# Access Compliance Report

## Public Rights-of-Way

Intersection ID: 53624	Main Street: PROSPERITY RIDGE RD	Cross Street: RIDGE RD	Location: SE
ADA ID: BDADE820E2AF	Ramp Type: Perp	Initial Pass/Fail: Fail	Overall Compliance: No
Severity Score: 25			
Codes/Mitigation Info/Possible Solution		Field Measurements/Component Compliance

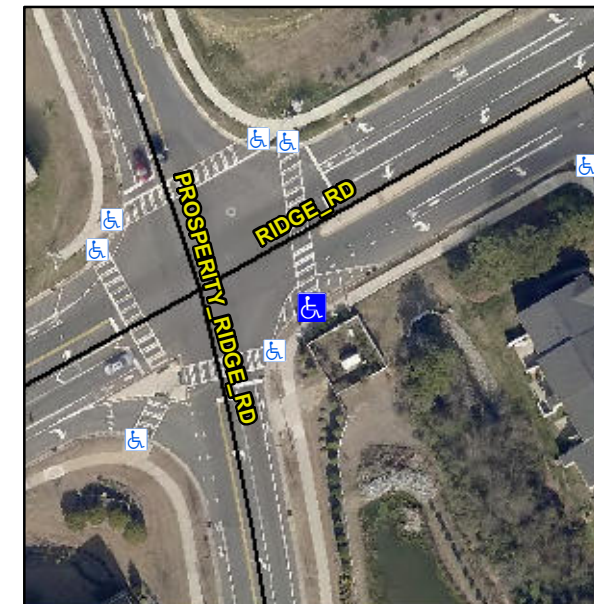
**Remove & Replace Entire Ramp.**

**R304.2.2**

Compliance	Description	Data	Compliance	Description	Data
N/A	Ramp Length (in)	38.0	No	Ramp Slope (%)	14.9
Yes	Ramp Width (in)	48.0	Yes	Ramp XSlope (%)	1.8
N/A	Flare Type LT	N/A	N/A	Flare Type RT	N/A
N/A	Flare Slope LT (%)	N/A	N/A	Flare Slope RT (%)	N/A
N/A	Flare Traversable LT?	N/A	N/A	Flare Traversable RT?	N/A
N/A	Landing Length (in)	N/A	N/A	DWS Provided?	N/A
N/A	Landing Width (in)	N/A	N/A	DWS Contrast?	N/A
N/A	Landing Slope (%)	N/A	N/A	DWS Length (in)	N/A
N/A	Landing X Slope (%)	N/A	N/A	DWS Full Width?	N/A
N/A	Landing Curb? (Y/N)	N/A	N/A	DWS Offset (in)	N/A
N/A	Shared Landing?	N/A			
N/A	Gutter Ponding?	N/A	N/A	Gutter Slope (%)	N/A
N/A	Gutter Lip Ht (in)	N/A	N/A	Gutter X Slope (%)	N/A
N/A	Painted X Walk1?	Yes	N/A	Painted X Walk2?	N/A
	X Walk 1 Direction	To N		X Walk 2 Direction	N/A
N/A	X Walk 1 Width (in)	120.5	N/A	X Walk 2 Width (in)	N/A
	X Walk 1 Slope (%)	1.4		X Walk 2 Slope (%)	N/A
	X Walk 1 X Slope (%)	1.8		X Walk 2 X Slope (%)	N/A
